Burlington Development Review Board

BURLINGTON DEVELOPMENT REVIEW BOARD

MEMORANDUM

RE: ZP-23-205; 655 Spear Street

EPSC PLAN

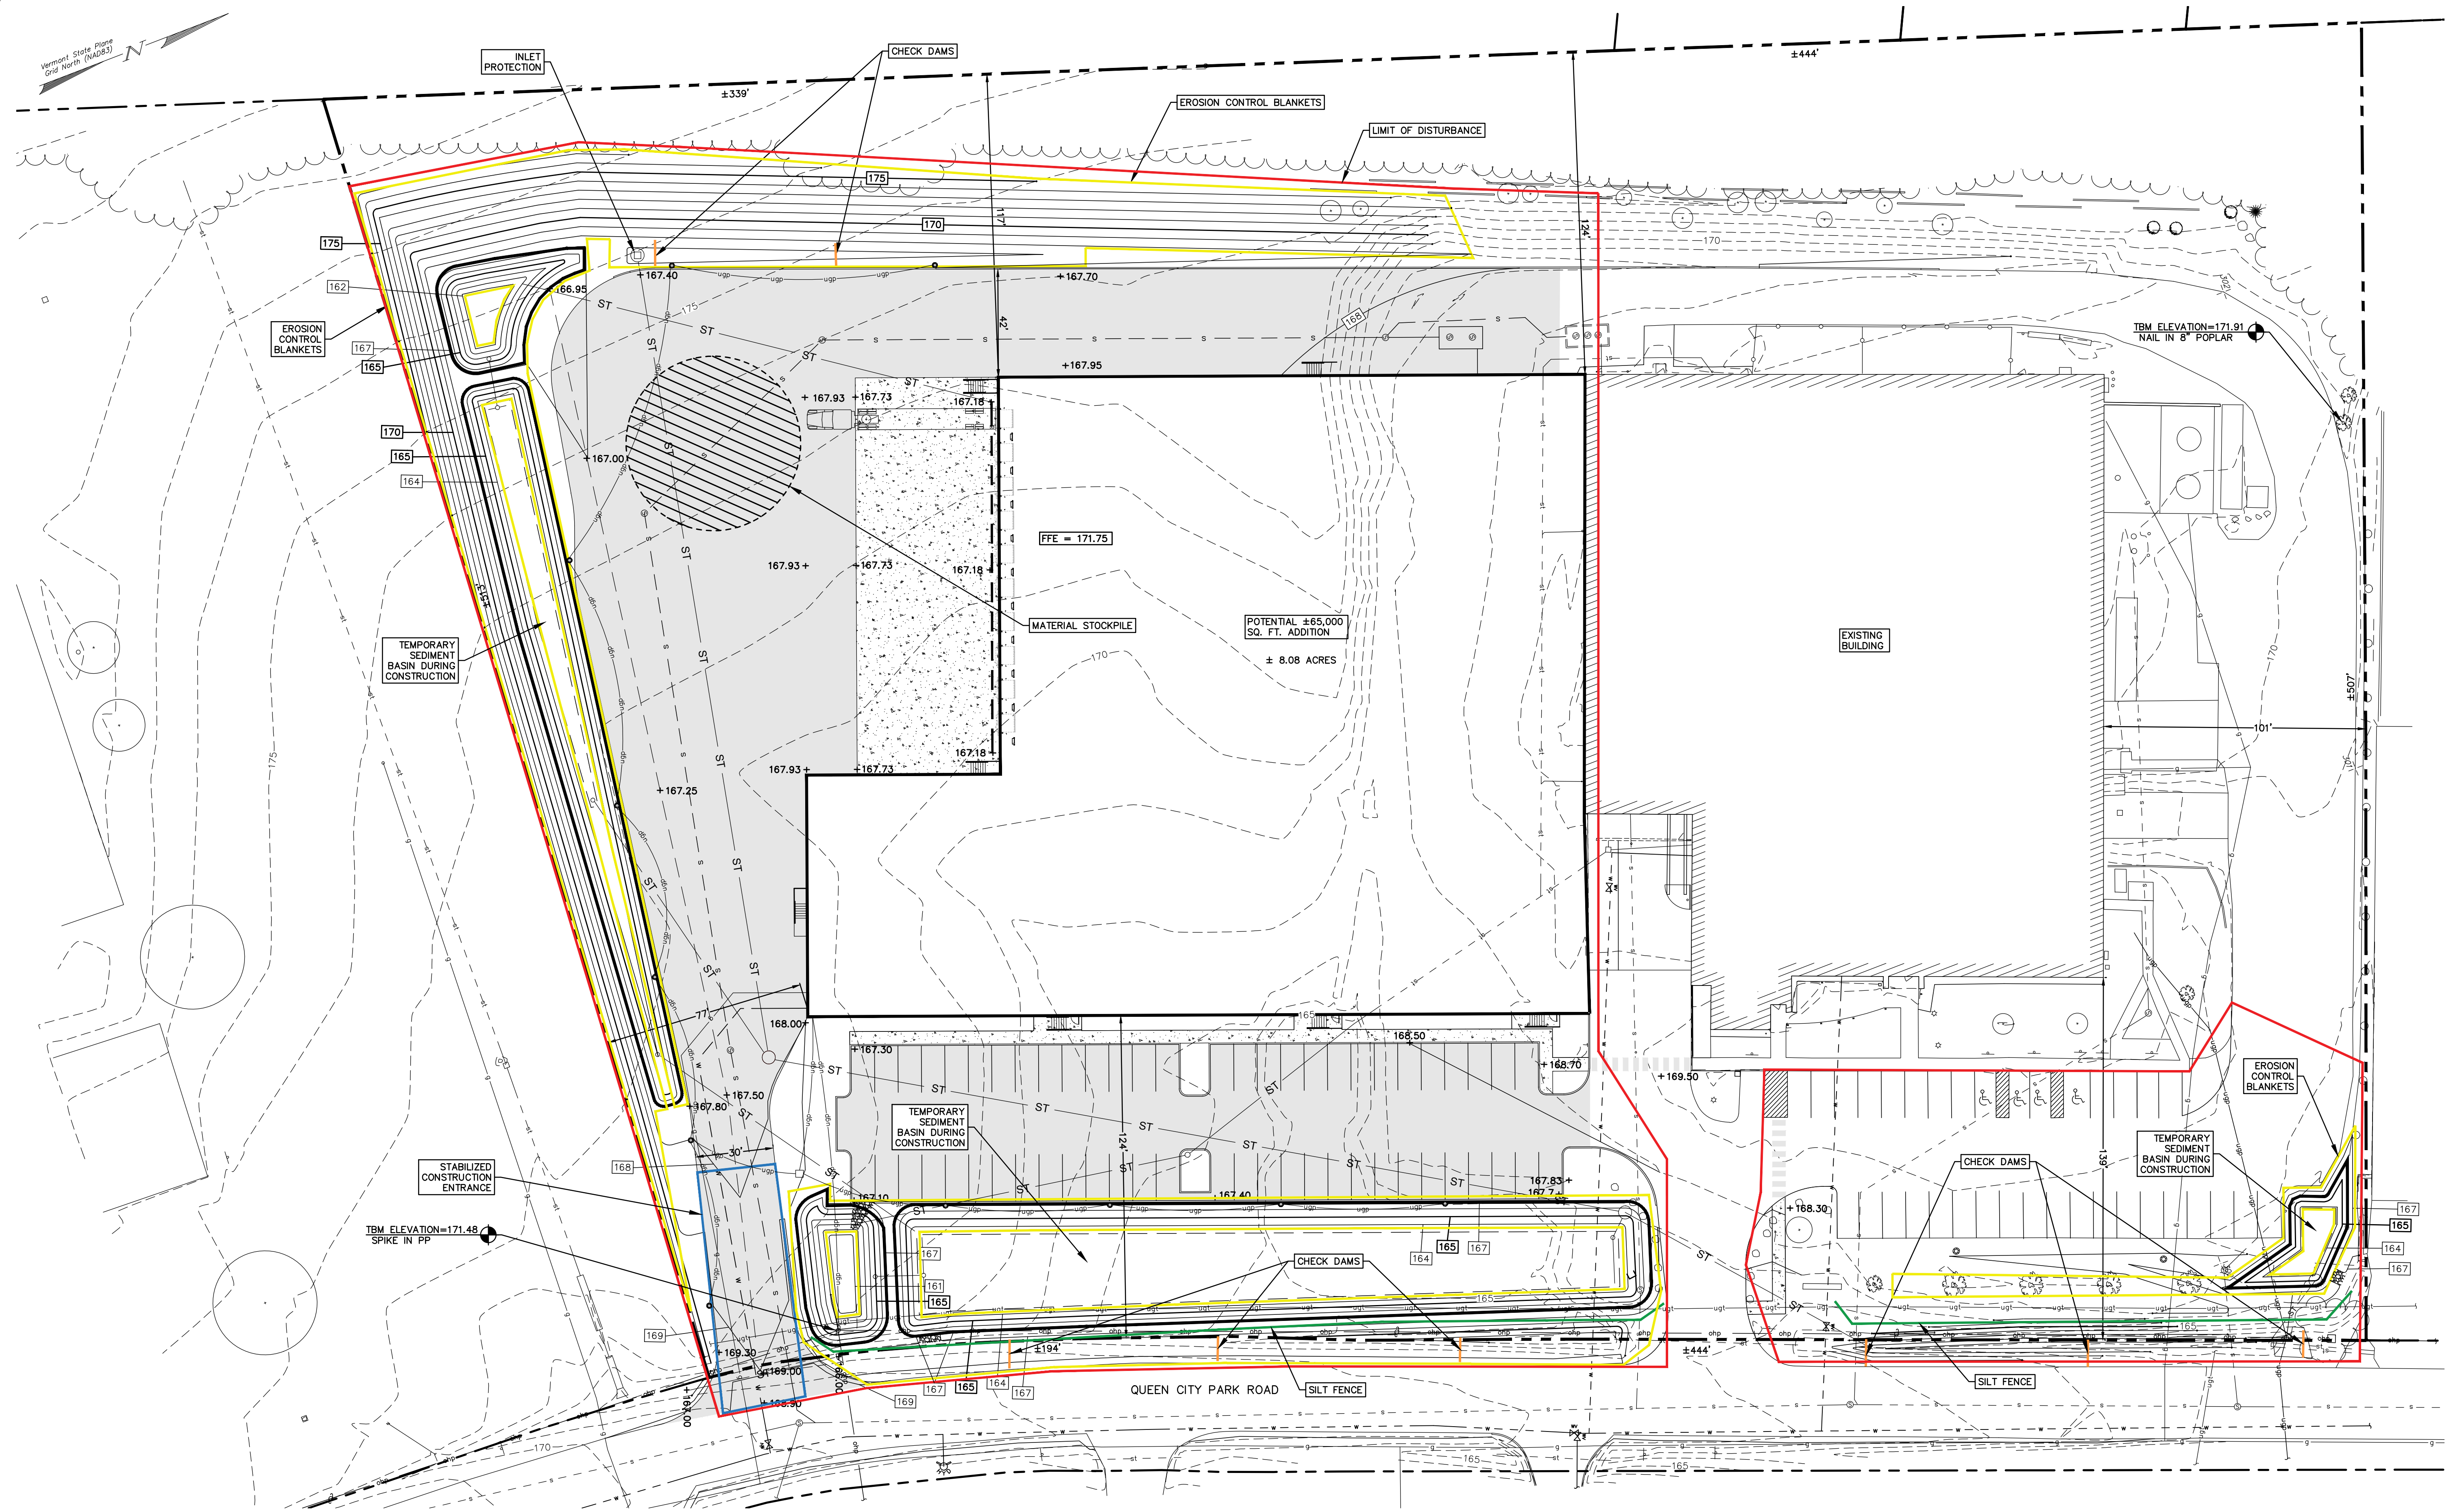
Over 400 square feet of land disturbance is proposed so an Erosion Prevention and Sediment Control (WPSC) plan is required. Sheet C-12 is an EPSC plan and Sheet C-13 contains the details associated with the EPSC plan. The EPSC plan utilizes a stabilized construction entrance, temporary sedimentation basins, stone check dams, erosion control blankets and silt fence. This plan will be submitted to the stormwater administrator via the online permit portal for review.
